**READING OPERATIONS CENTER DRIVER BREAKROOM & SHOP BAY
RENOVATION PROJECT
PROJECT # 10-2026
For the
SOUTH CENTRAL TRANSIT AUTHORITY**

ADDENDUM NO. 2

Addendum #2

Questions and Answers

A-101

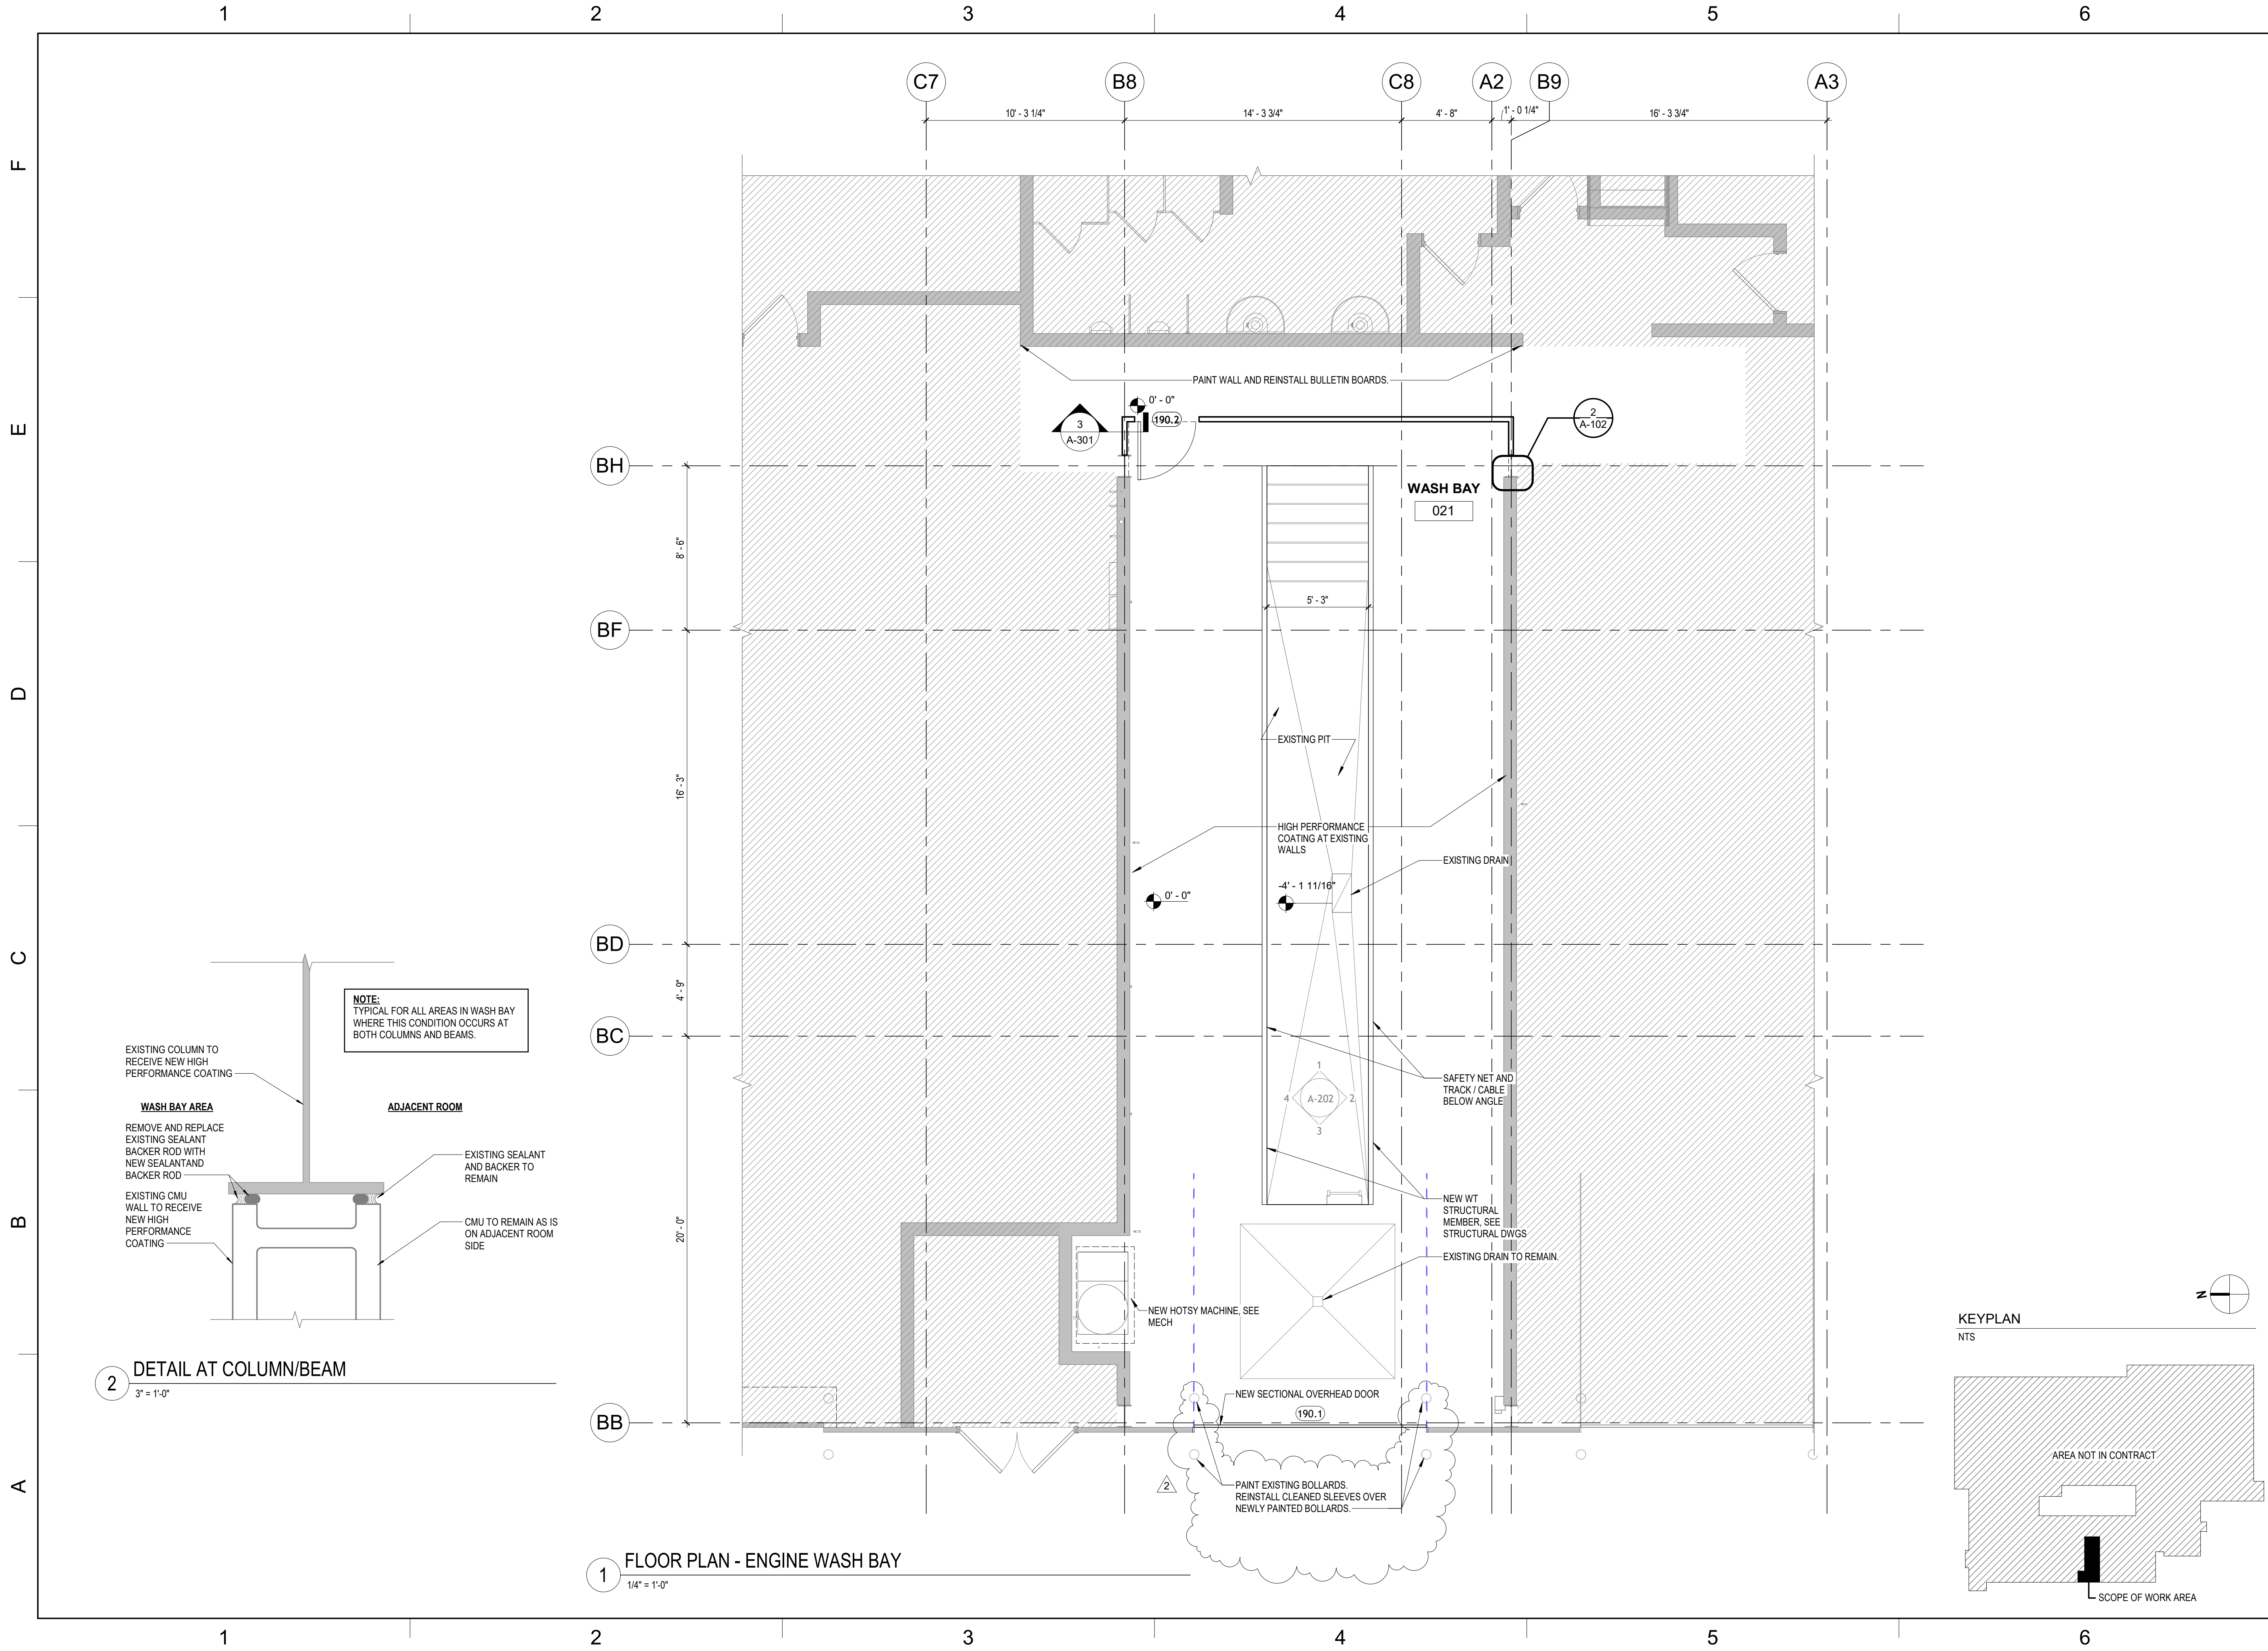
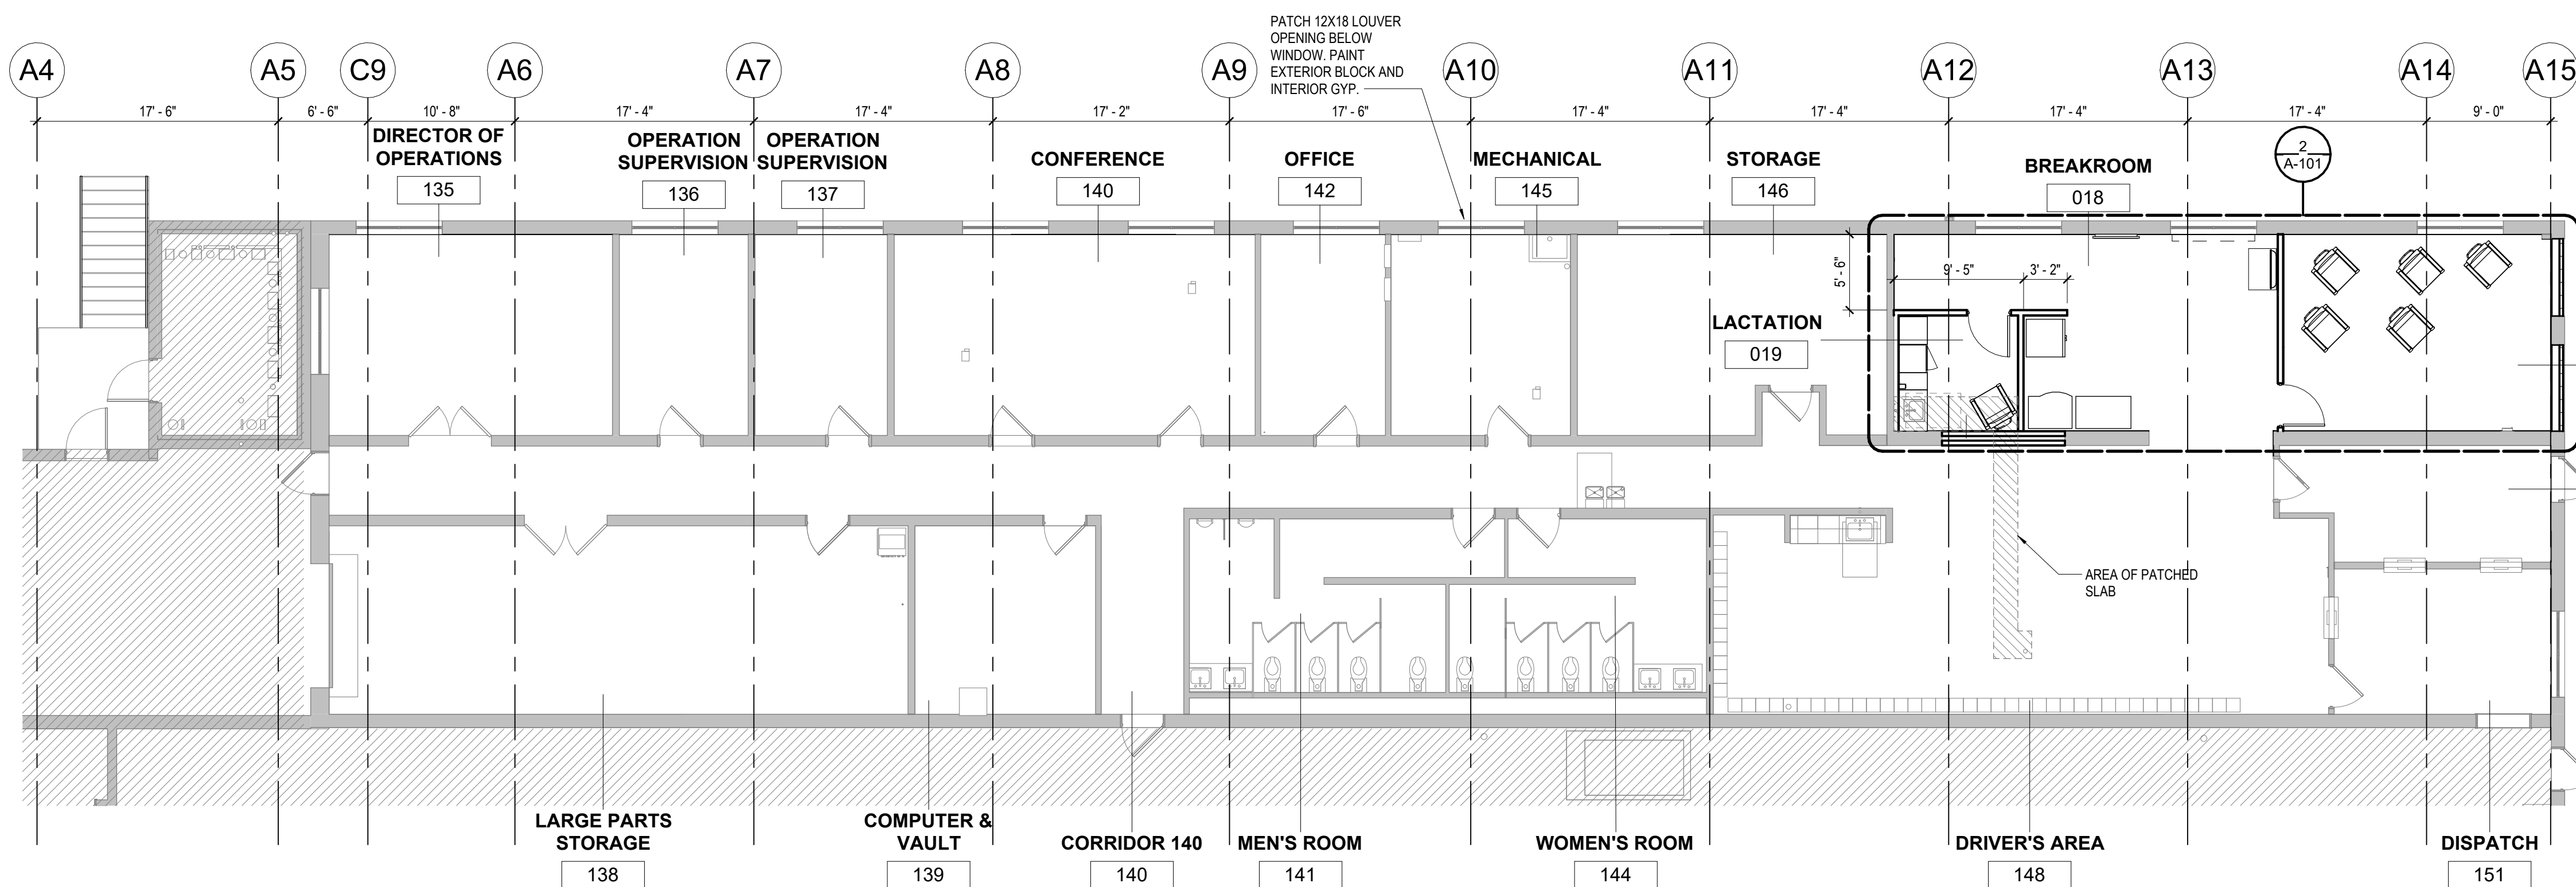
4. Are the lounge chairs shown in the Lactation Room and Driver's Lounge by owner as stated on Drawing A-101 or by the GC as called out in the specifications?

SCTA RESPONSE: Lounge chairs are by GC.
